1 - 179 Padstow House, Hull

Type 3 Fire Risk Assessment

Prepared for:	Rebecca Franks, Building Safety Manager
Prepared by:	John Askew, Fire Risk Assessor, Holistic Fire Safety
Date:	01/10/2025
Document Reference:	HFS.HCC.PadstowHouse.FRA.3.0

Photo 39

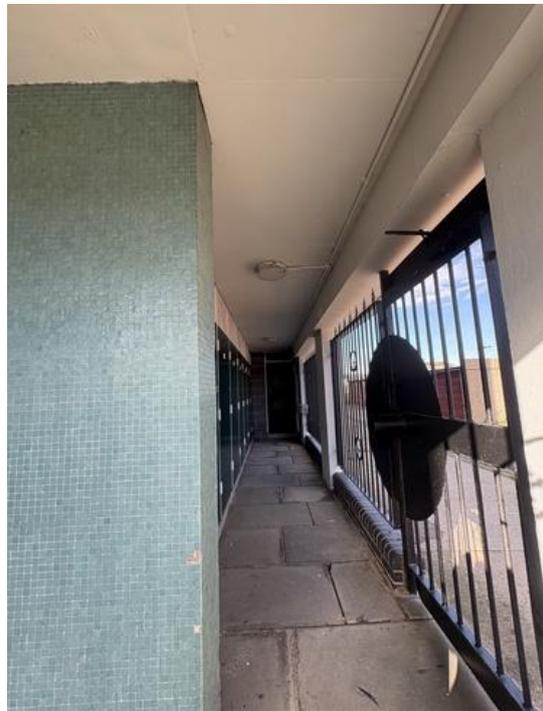
Removal of cement board in resident storage / ancillary areas and above walkways on the ground floor in identical properties has revealed the installation of insulation. It is understood this was originally installed to provide thermal insulation for first floor accommodation above.

It has been confirmed the insulation present is flammable and should be removed. Any replacement should achieve Class A2-s1, d0 or better.

Remove insulation in areas on the ground floor. Any replacement should achieve Class A2-s1, d0 or better.

Photo 44

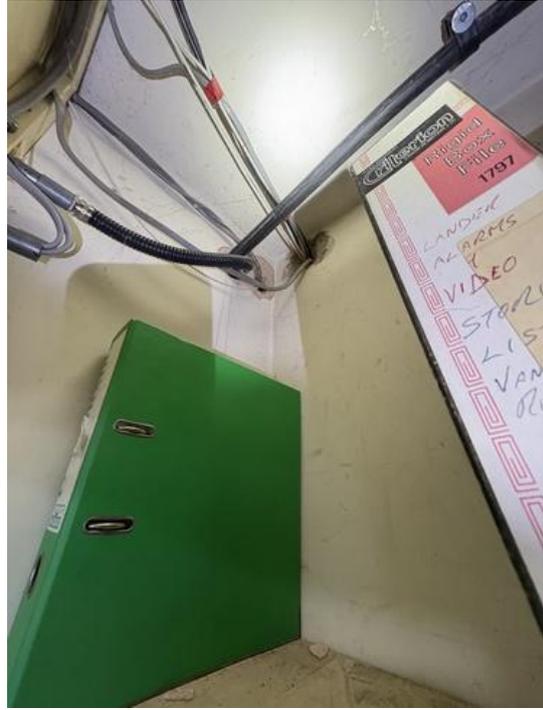
Ceilings within escape routes, however, are lined with ceiling tiles which are suspected to be of a combustible nature. Although there is a concrete slab which separates floors, should tiles be subjected to ignition, it is foreseeable that they would contribute towards fire growth; as a result, tiles should be removed throughout all areas.

Remove combustible ceiling tiles from escape routes and furnish with materials which meet Euro Class B-s3, d2 or better to inhibit any lateral fire spread.

Photo 54

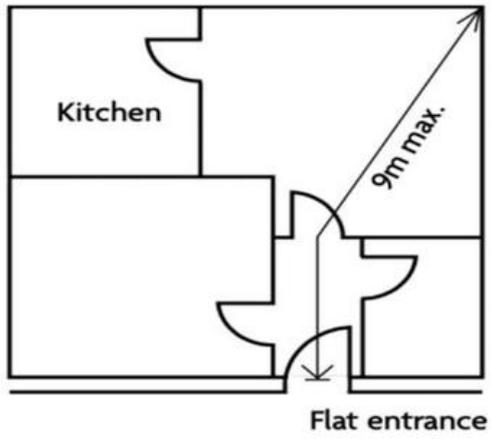
Within refuse chutes there was a single soil vent pipe which travelled vertically through all floors which was not appropriately fire stopped using a suitable closing device. Remediation is to consist of installing a suitably sized intumescent fire collar.

Large sections of what appear to be plywood boards, which make up the curtain walling, are located within the refuse areas to one side of the building. It is unknown what is behind the boarding although it is suspected to be the lift shaft. HCC representatives believe there are voids behind the boarding therefore, it is advised to carry out intrusive investigation to determine if there are breaches to lines of compartmentation which would allow the passage of heat and smoke.

Carry out intrusive investigation to the boarded area within refuse chute to the south side of the building.

Photo 66

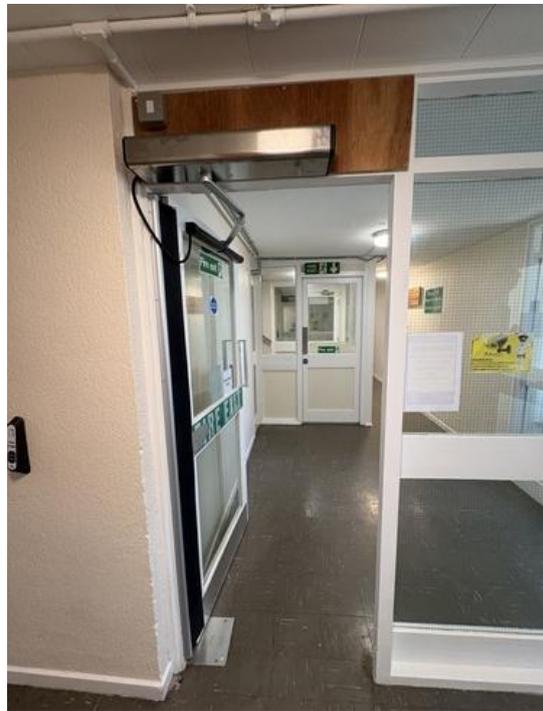
Maintenance labels on electrically operated automatic doors were noted to be either in excess of test frequencies or not displaying labels.

HCC to confirm automatic doors are subject to maintenance in accordance with manufacturers instructions.
